**PRELIMINARY & FINAL DRAINAGE REPORT
FOR
ELLCOTT TOWN CENTER – FILING NO. 1**

Engineering Review

**JPS Project No. 030502
EPC Project No. SF-18-025**

SHEET: **D1.01**

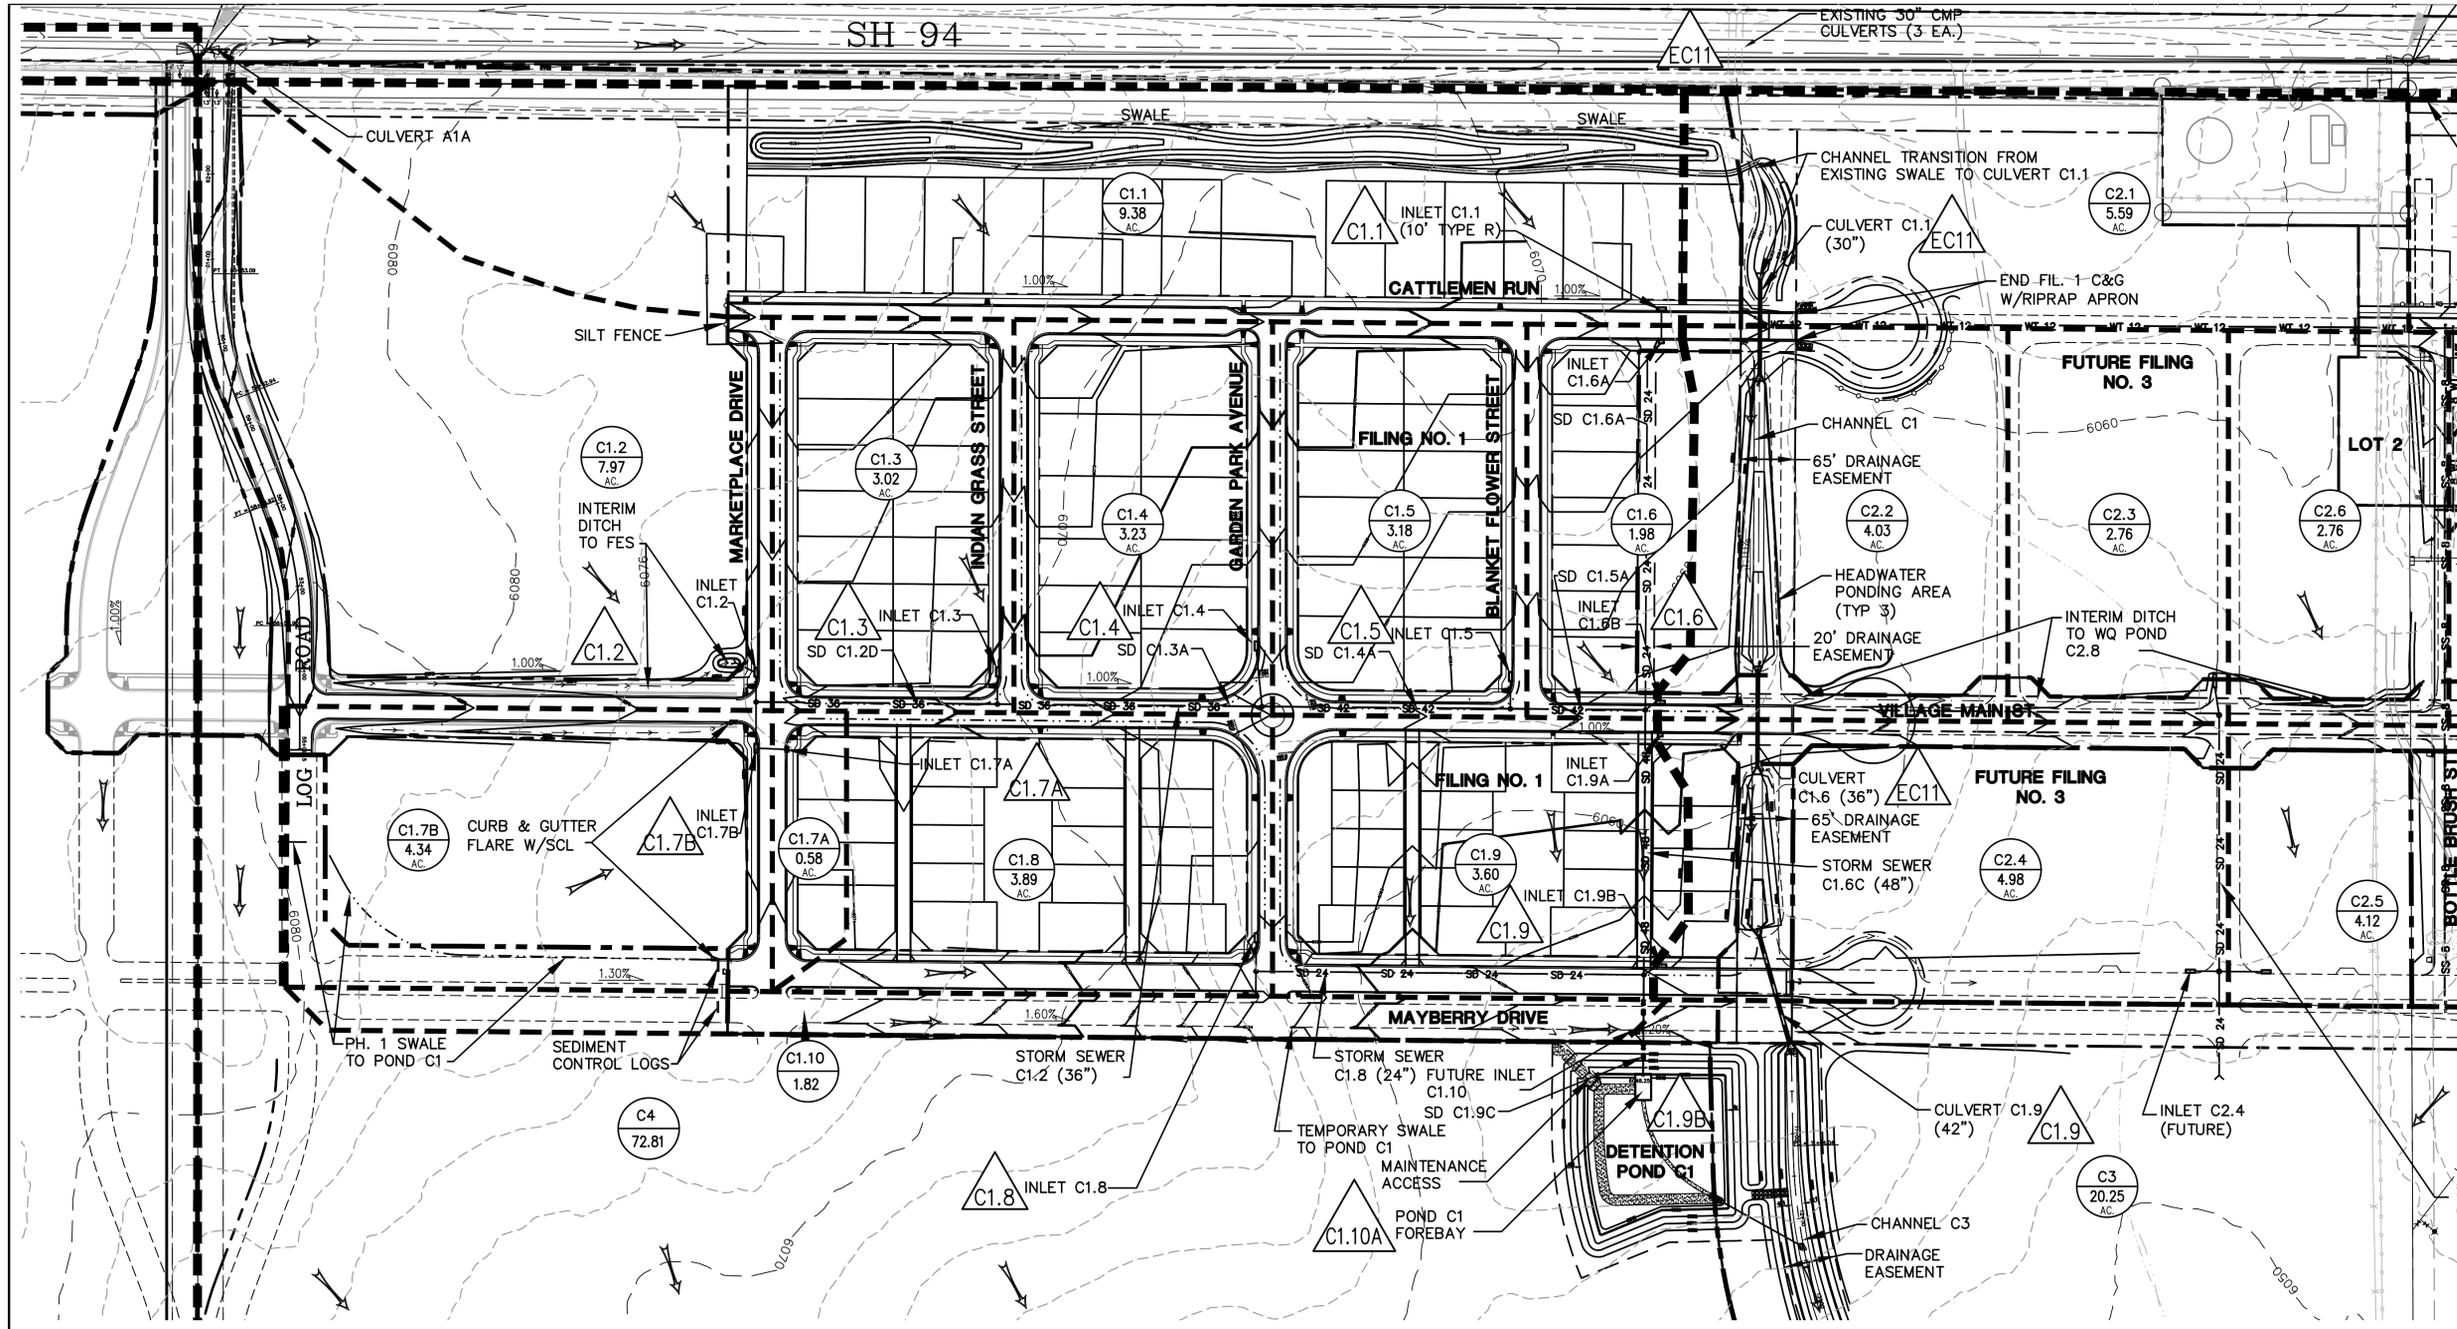
Provide area (if less than 1 acre a deviation is not required)

Add that this area will be fully revegetated except for x.xx acre of impervious area of roads...

SHEET: C1.05

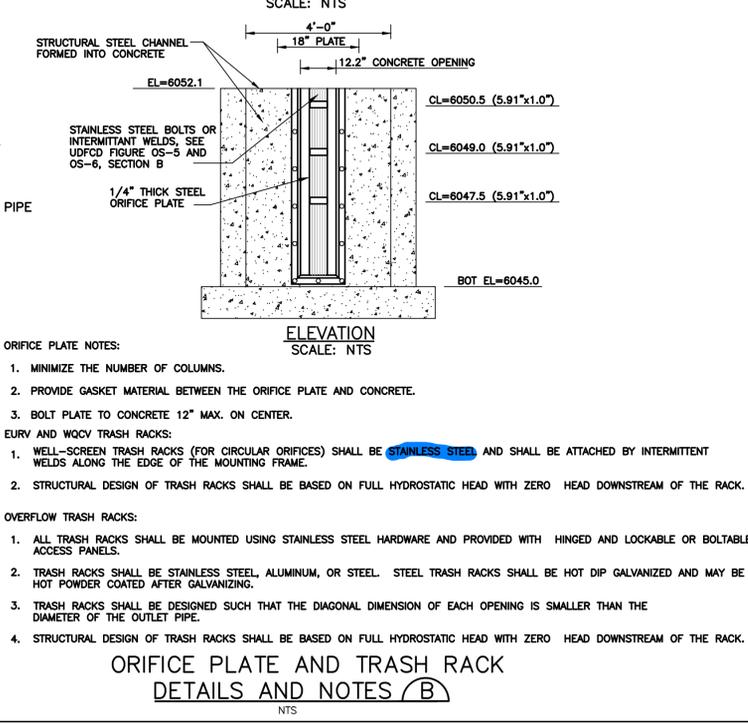
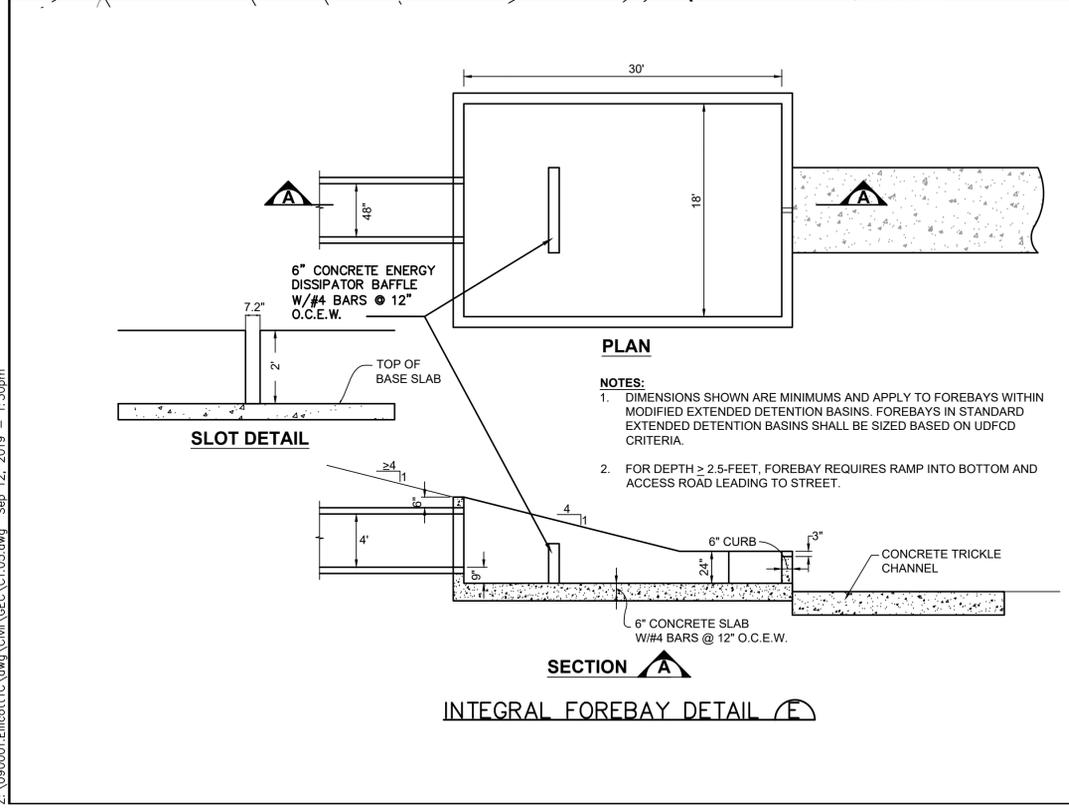
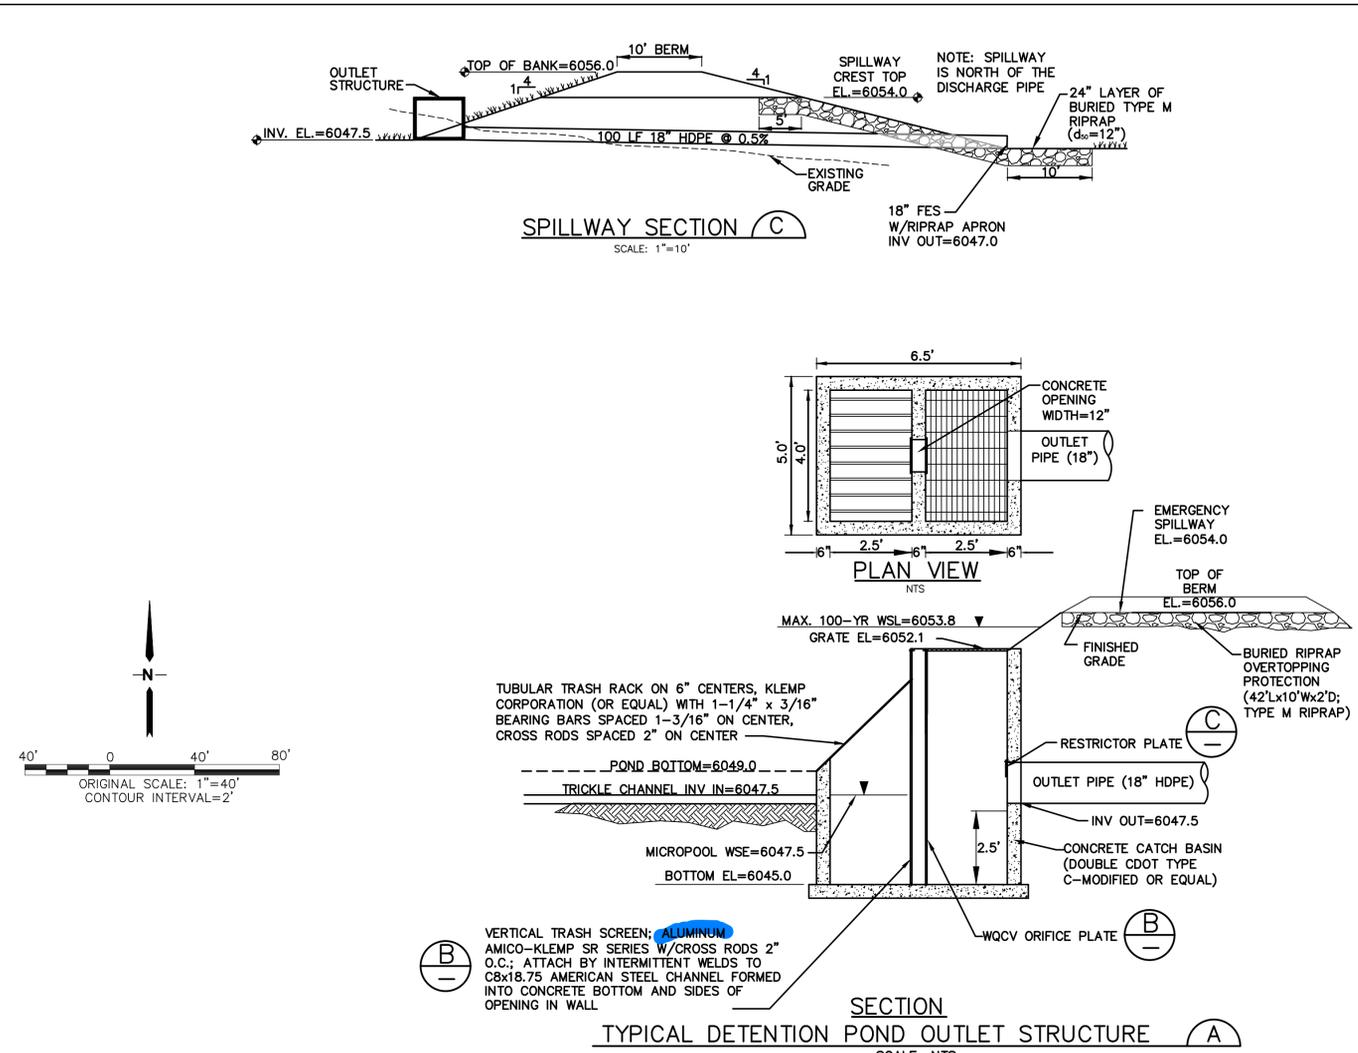
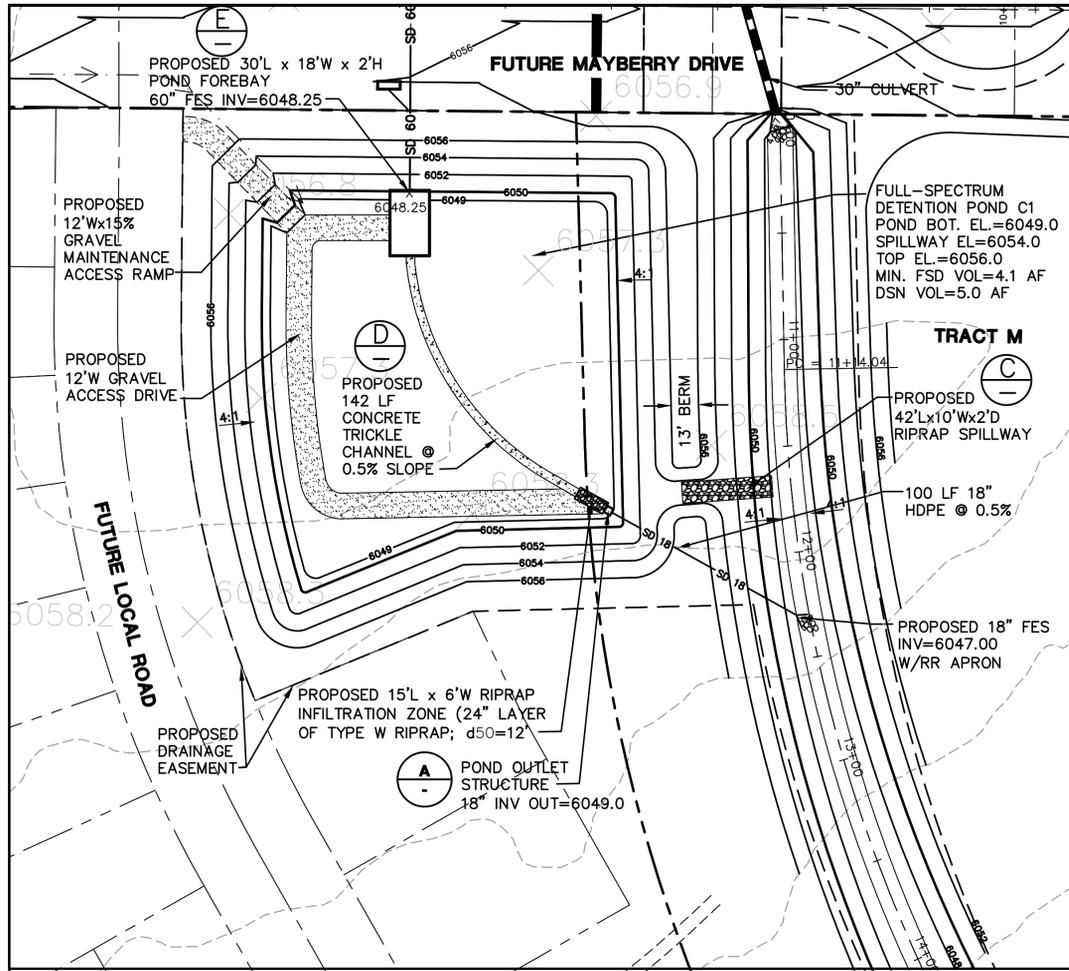
Alternate detail is recommended for ease of maintenance
